Technical Service Bulletin

No.JTB00077v2
11 July 2008

Subject/Concern:	'Moan' Noise from Rear Brakes When Reversing or Manoeuvring Slowly
-------------------------	--------------------------------------------------------------------

X-TYPE	Two wheel drive.	Two wheel drive. VIN-range: E24054-J28416
X-TYPE	All-wheel drive (North America).	All-wheel drive (North America). VIN-range: E24054-J35344
X-TYPE	All-wheel drive (Rest Of The World).	All-wheel drive (Rest Of The World). VIN-range: E24054-J39172

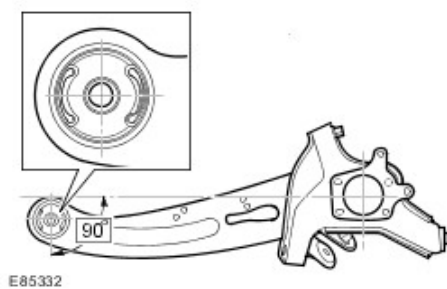
- Remove rear knuckle front bushing (see Global Technical Reference GTR Workshop Manual, section: 204-02 - Rear Suspension - Wheel Knuckle Front Bushing (64.15.28)).
- NOTE:** The new bushing are voided, and the voids need to be in the correct orientation when installed (see E85332).
